MFN 06-407  
Supplement 2

**Subject: Response to Portion of NRC Request for Additional Information Letter No. 38 Related to ESBWR Design Certification Application – Structural Analysis - RAI Numbers 3.8-81 S01, 3.8-85 S01, 3.8-86 S01, 3.8-88 S01, 3.8-92 S01, 3.8-93 S01, 3.8-94 S01, 3.8-96 S01 and 3.8-99 S01**

**RAI Numbers 3.8-81 S01, 3.8-85 S01, 3.8-86 S01, 3.8-88 S01,  
3.8-92 S01, 3.8-93 S01, 3.8-94 S01, 3.8-96 S01 and 3.8-99 S01**

Figure 3.8-93(3)-c Comparison of Basemat Sectional Moments ( soft x3)

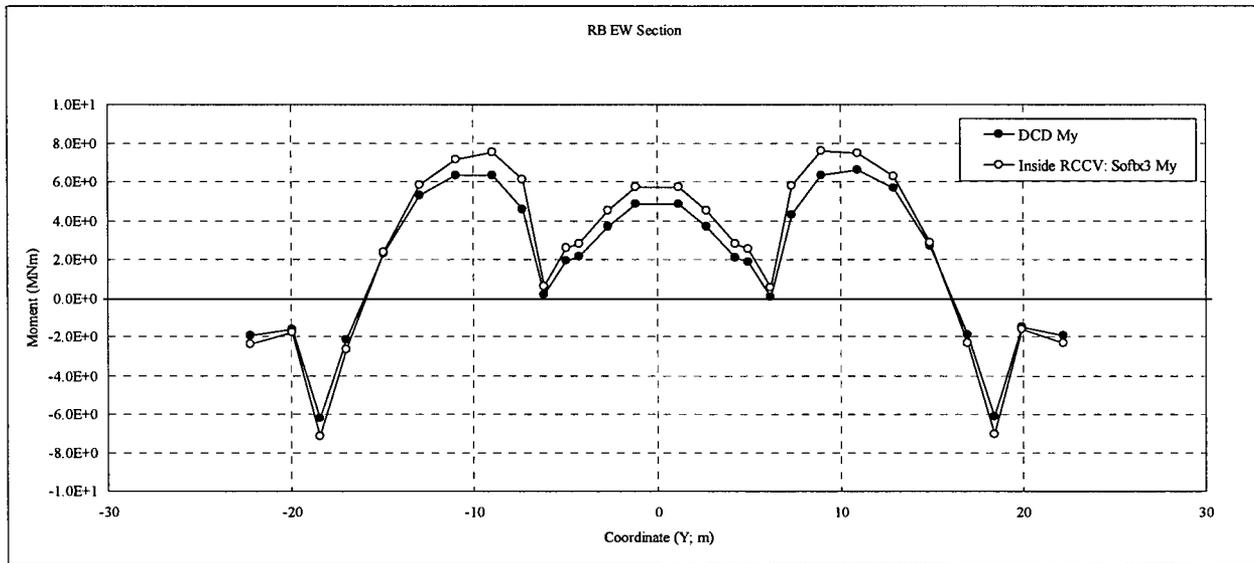
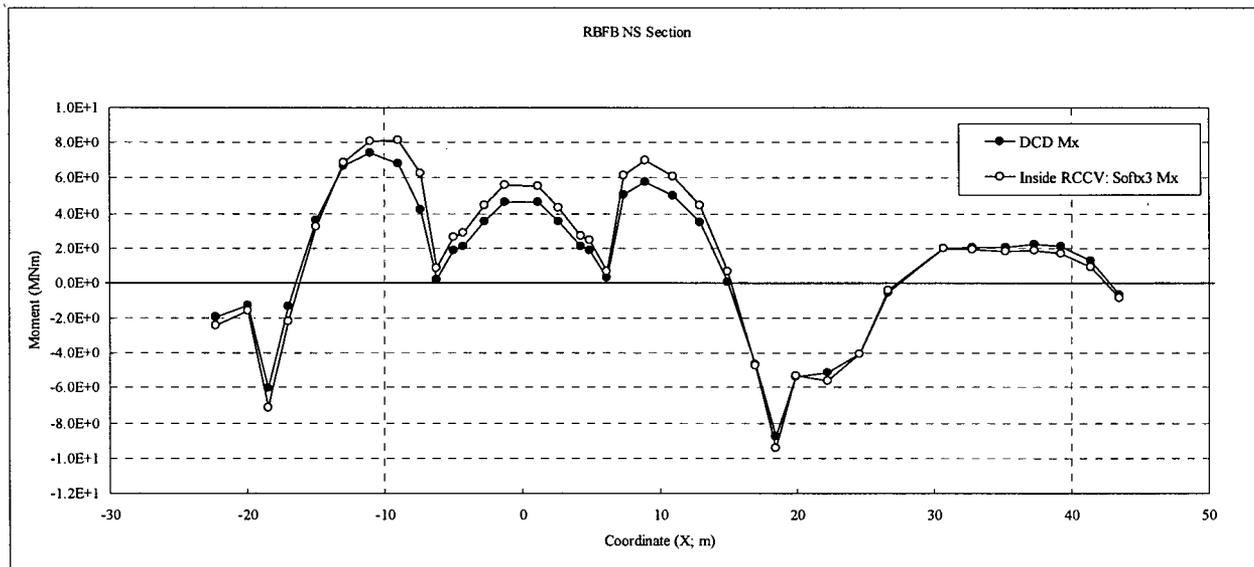
*GE needs to explain why DCD Section 3.8.6.2 has been deleted and state where it will be documented in the DCD that "The COL holder will have to demonstrate that differential settlements at the site do not exceed this value by instituting a settlement monitoring program or justify in the COL why it would not be necessary." GE also needs to: (1) clarify "this value" in the previous sentence, (2) why only dead load is considered in the evaluation and clarify what loads are included in the dead load, (3) why is the pedestal area the only area considered to have a potential "hard spot," (4) explain the sentence "Assumed sequence is as follows, but this is imaginary since these portions are constructed in short time periods," (5) clarify if the two construction sequences (Case A and Case B) are a COL requirement, and if not, why not, and (6) why aren't hard spots considered in the construction phase. (7) In the evaluation for variation of horizontal soil springs, were the walls also reviewed in addition to the mat? (8) Regarding Fig. 3.8-93(3)-c, GE needs to explain why the soft X 3 case exceeds the base case.*

- (8) The bending moment distributions were compared for three cases of horizontal soil stiffness variation under the basemat in the original response to NRC RAI 3.8-93 in MFN 06-407. In the original response, the Softx3 case exceeded the base case. The evaluation mentioned in Item 3 above, *Basemat Design Considering Horizontal Variation of Soil Springs*, clarifies the result of horizontal variation of soil springs. Figure 3.8-93(24) shows the relative displacement normalized to the basemat displacement at the centerline position of the RB. It is found that the "Hard Spot" condition results in a different pattern of relative displacements when compared against the DCD Tier 2 analysis results. As a result, a limitation for the maximum variation of horizontal soil stiffness in terms of shear wave velocity is imposed as a COL item stated in Item 3 above.

Figure 3.8-93(25) Zone of Basemat for Concrete Pour

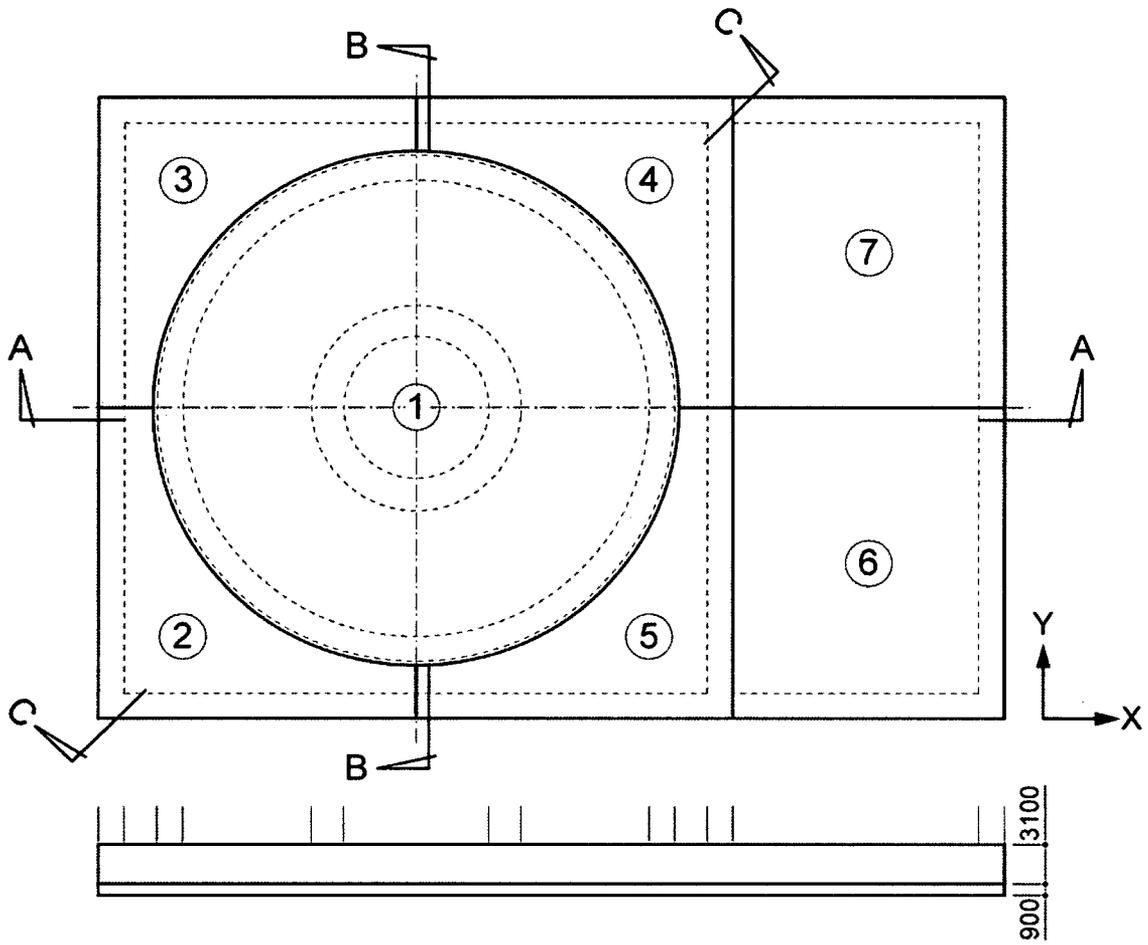
*(5) Regarding the need to specify general construction sequences in the DCD, which were the basis of the design, GE indicated that they will perform additional calculations to consider the effects of the construction sequence of the concrete mat pour and the effects on design. These evaluations will include consideration of the governing soil properties. GE expects that these bounding type calculations will show that the resulting forces and deformations are small. If so, GE will revise the DCD to indicate that the requirements for construction of the mat (based on these evaluations) will be specified in the construction specifications. If not, then a more detailed description of the construction requirements will be provided in the revised DCD.*

Based on the construction techniques and experience of a recent ABWR plant basemat, the RBFB basemat is divided into 7 concrete pour zones (see Figure 3.8-93(25).)
